Certificate of Appropriateness

1200 E. Brady Street, Brady Street Historic District

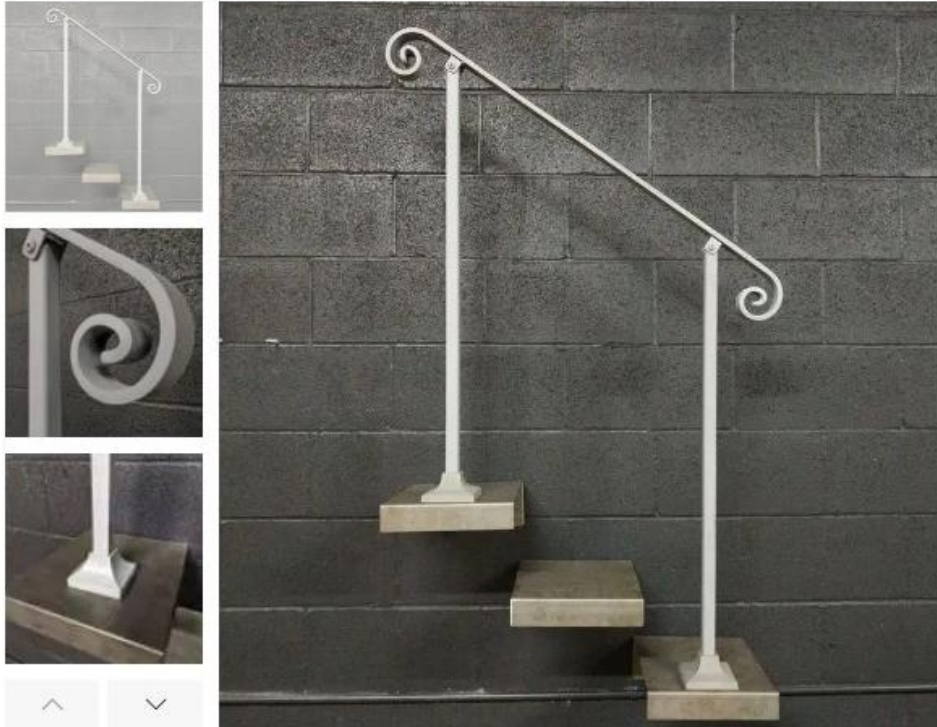
Railing design to replace existing broken handrails. Rail will be finished in black.

Existing doorway and doorway mockup with new Doug Fir Italianate-style door and new wood transom window

All finish wood must be smooth and free of knots and must be painted or treated with an opaque stain upon completion. Note: when new, bare wood is left exposed to the exterior elements for a period of only a week or two, the life of the paint job subsequently applied to it will be decreased. The use of a decay-resistant wood for is required for porch areas. Using western white pine or Ponderosa pine is "at your own risk" because this wood has no natural decay resistance and can deteriorate in some exterior settings in just a few years.
